TRANS/WP.29/944

World Forum for Harmonization of Vehicle Regulations (WP.29)

DRAFT SUPPLEMENT 3 TO THE 05 SERIES
OF AMENDMENTS TO REGULATION No. 83

(Emissions of M₁ and N₁ categories of vehicles)

Condition A of the Type I test

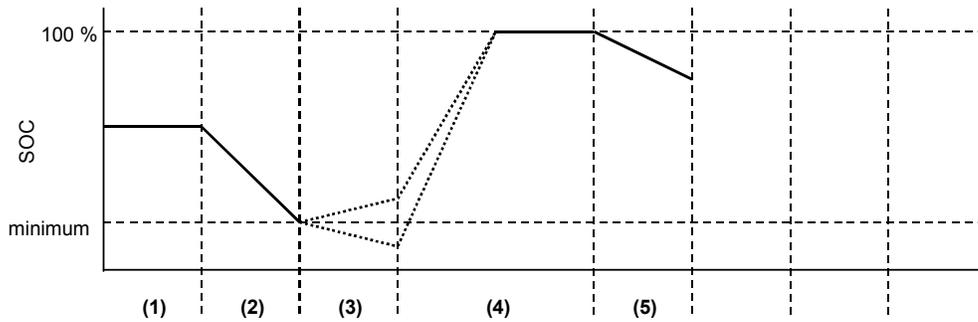
- (1) initial electrical energy/power storage device state of charge
- (2) discharge according to paragraph 3.1.2.1. or 3.2.2.1.
- (3) vehicle conditioning according to paragraph 3.1.2.2. or 3.2.2.2.
- (4) charge during soak according to paragraphs 3.1.2.3. and 3.1.2.4., or paragraphs 3.2.2.3. and 3.2.2.4.
- (5) test according to paragraph 3.1.2.5. or 3.2.2.5.

Condition B of the Type I test

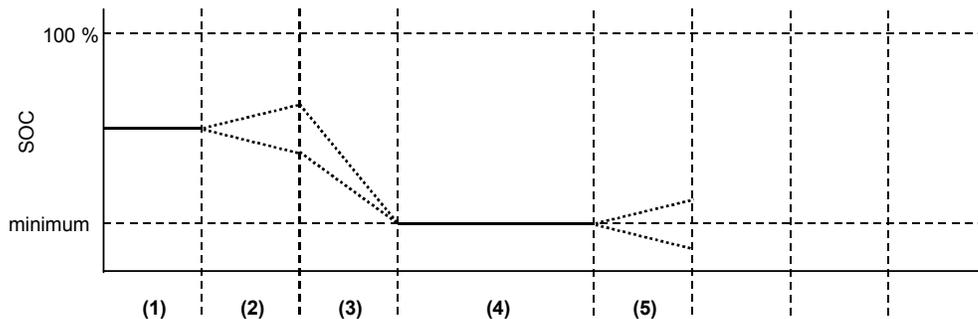
- (1) initial state of charge
- (2) vehicle conditioning according to paragraph 3.1.3.1. or 3.2.3.1.
- (3) discharge according to paragraph 3.1.3.2. or 3.2.3.2.
- (4) soak according to paragraph 3.1.3.3. or 3.2.3.3.
- (5) test according to paragraph 3.1.3.4. or 3.2.3.4.
